ADDENDUM NO.3

Date: **July 1, 2021**

Subject: **Addendum No.3 to Contract Documents
City of Mercer Island
Booster Chlorination System Project (Bid #21-28)**

Butterfly Valves/Actuators were quoted from manufacturers with lead times of 30-38 weeks.

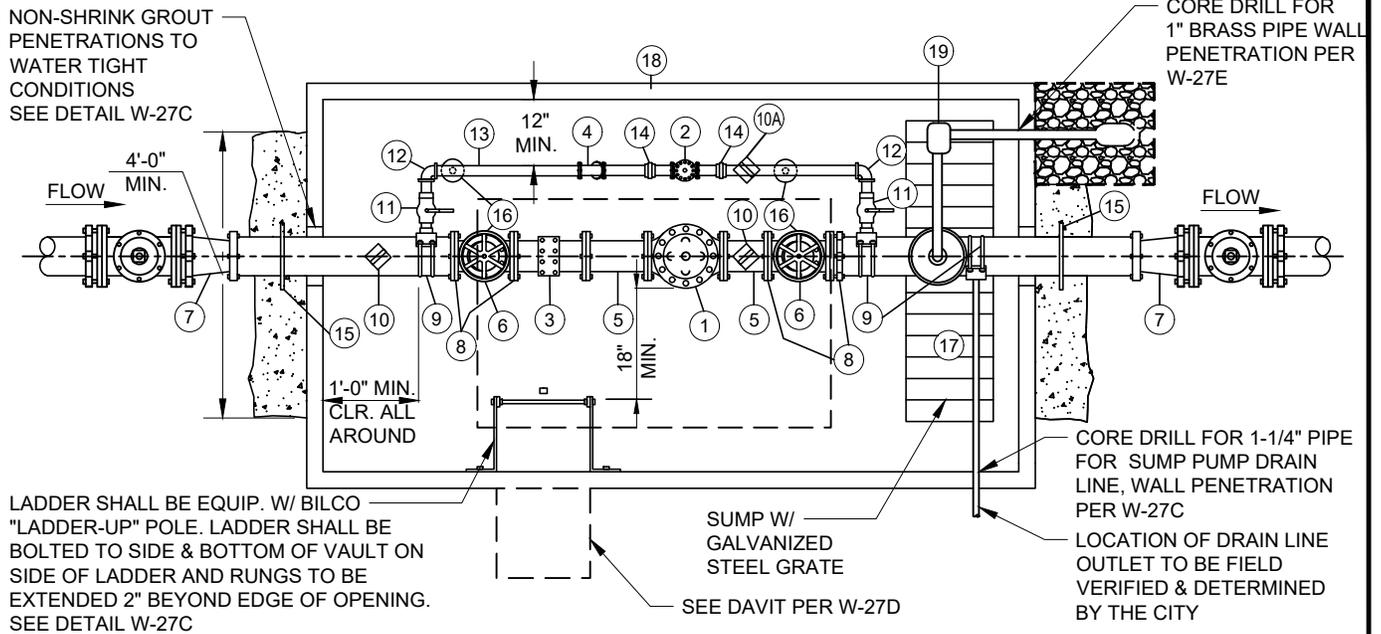
- 9) Lead times for valves varying from 30-38 weeks from approved submittal which creates a problem with meeting the completion dates noted on the bid form. Will the work be able to be extended due to these lead times?

Response: The Completion Time provided in BIDDING REQUIREMENTS page A-2 will not be changed at this time. However, the final construction duration may be extended without penalty during the schedule review and approval when actual lead times are determined.

W-27A

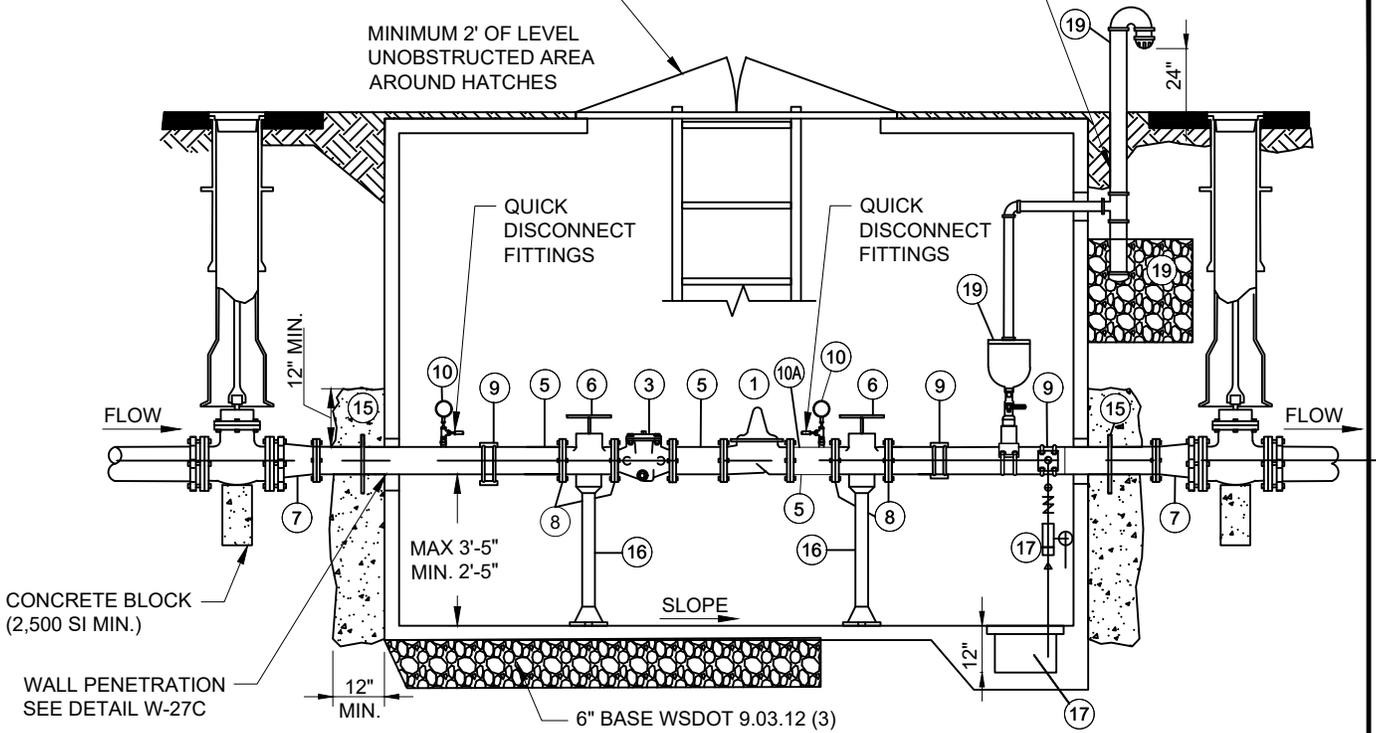
- 6) DRAWING C06 (Sheet 13 of 56)
 - a. REPLACE Key Note 7 with “7. LOW FLOW PRV CLA-VAL MODEL 92G-01BCVKC, OR EQUAL.”
- 7) DRAWING NO. TW01 (Sheet 55 of 56)
 - b. REPLACE Details W-27A, W-27B, W-27C, W-27D, and W-27E with attached Details.
